I hereby give notice that a hearing by commissioners will be held on:

PRIVATE PLAN MODIFICATION 44
HEARING REPORT
VOLUME ONE
33-37 GEORGE STREET, NEWMARKET
NEWMARKET HOLDINGS DEVELOPMENT
LIMITED PARTNERSHIP

Plate 5 – annotated extract from Applicant ALVE ZTV Map 1 to determine maunga intervisibility

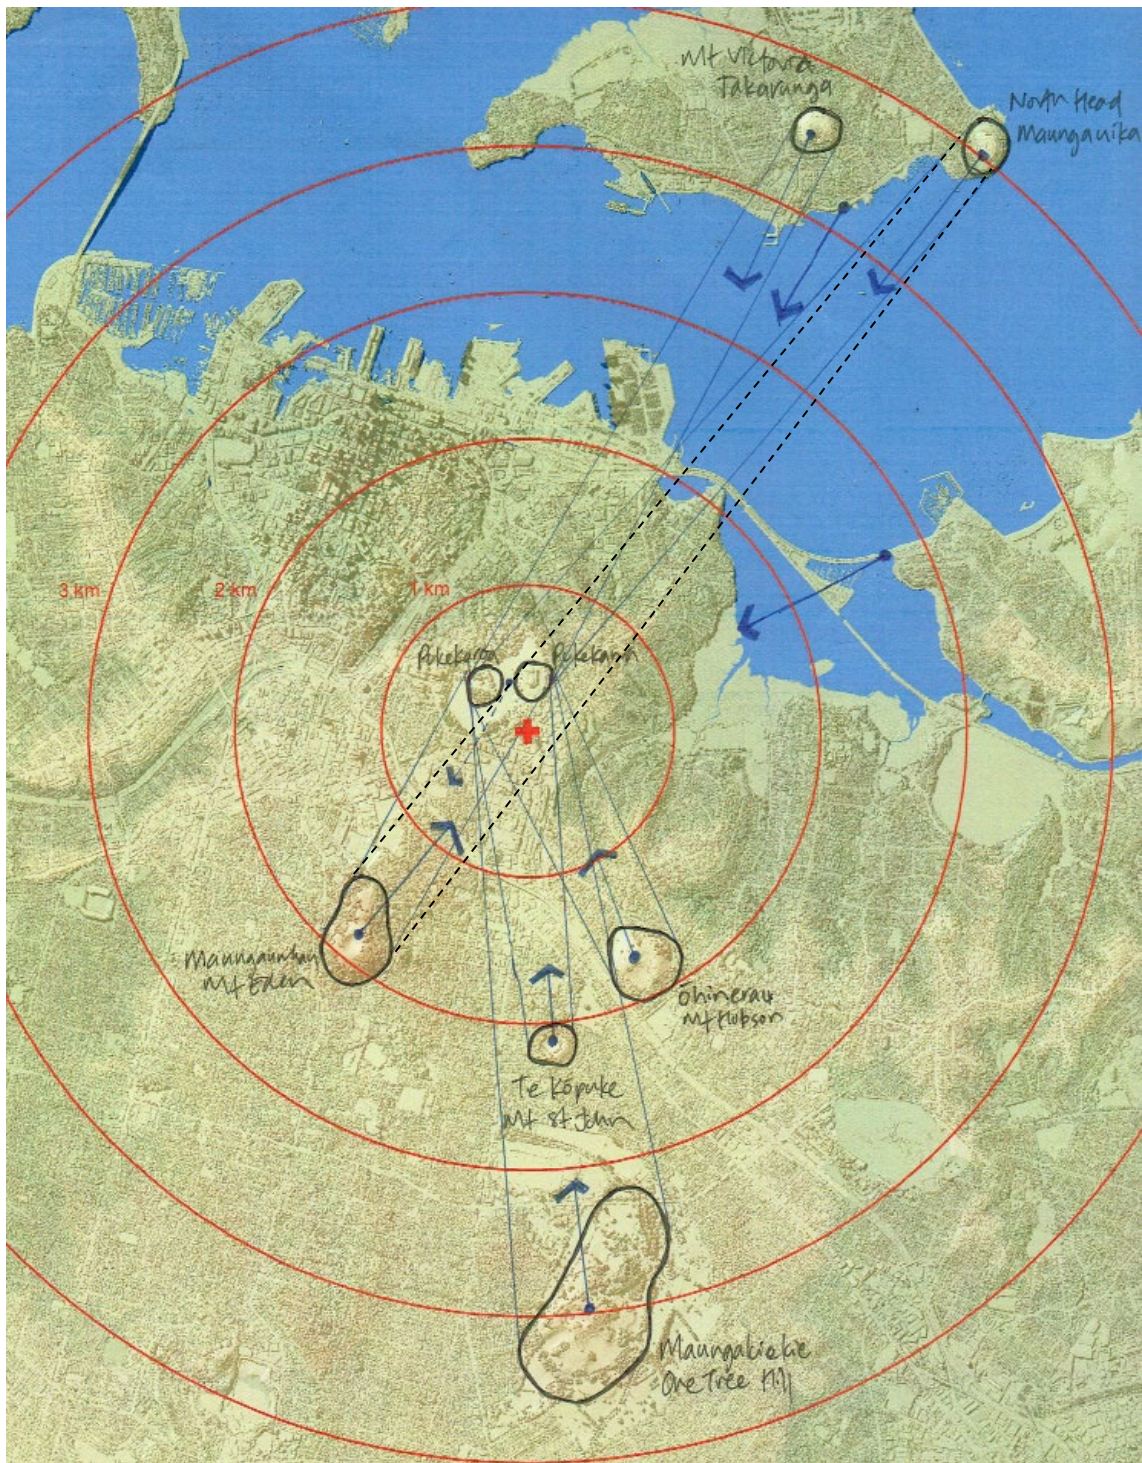
- 8.16 As outlined in paragraph 8.8 above, in my opinion, within the context of the AUP(OP) RPS Objective B4.3.1.(1) and Policies B4.3.2(1) and B4.3.2.(3), alongside the IMP Value / Pathway 8.7, a consideration of the impact of development enabled by the Proposed Provisions on the visual connection between proximate maunga, plus the significance of these views, is a relevant issue for consideration as part of a robust section 32 analysis.
- 8.17 In this regard, my illustration in **Plate 5** below is a mark-up of Map 1 from the Applicant ALVE ZTV drawings which, alongside my site visits and Asterix my analysis of photographs and the Applicant ALVE Photomontages, has informed my analysis of the potential impact of future built form on the site (marked as the red cross in this image) when considering maunga intervisibility.

Plate 13 – Maximum RL (Auckland 1946 VD) heights of component parts of the Auckland Museum building

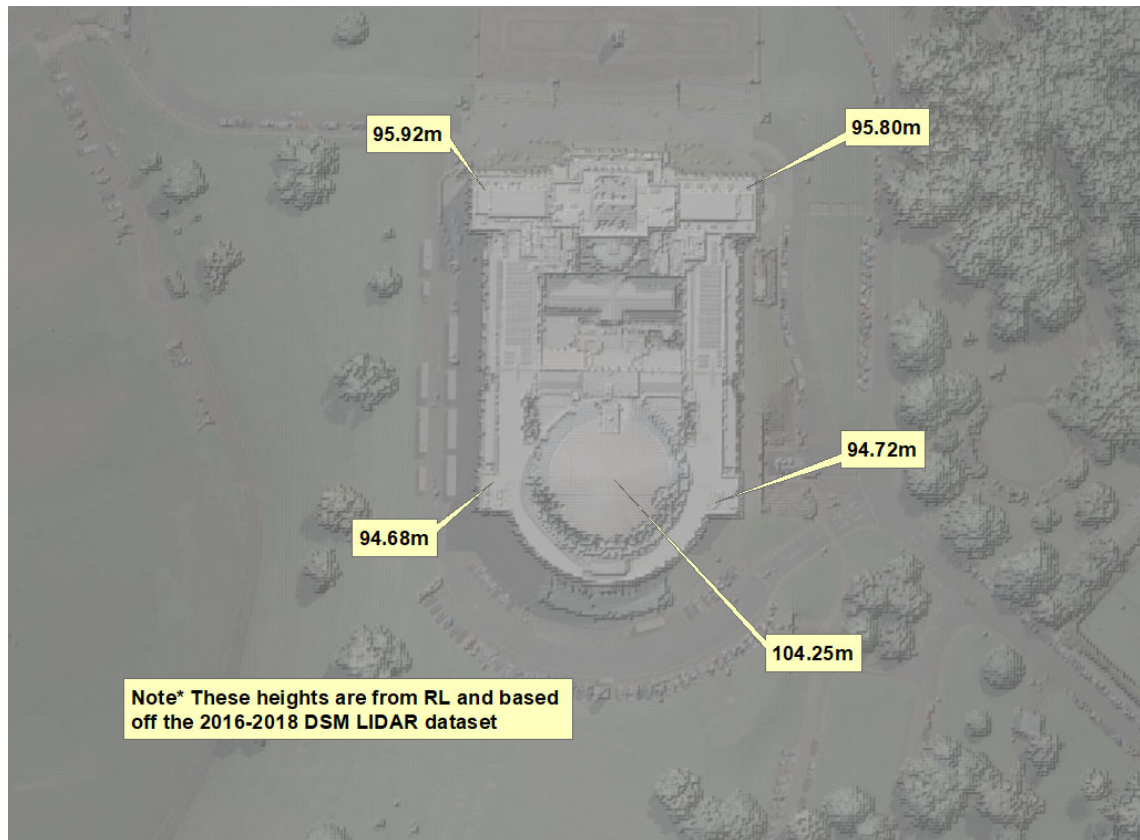
- 8.45 In my opinion, the proposed maximum building height within 'Height Area A' (at RL121) is too great when considered in the context of the surrounding landform and relative building heights of existing buildings in the landscape, including the Auckland Museum (refer **Plate 13** below).
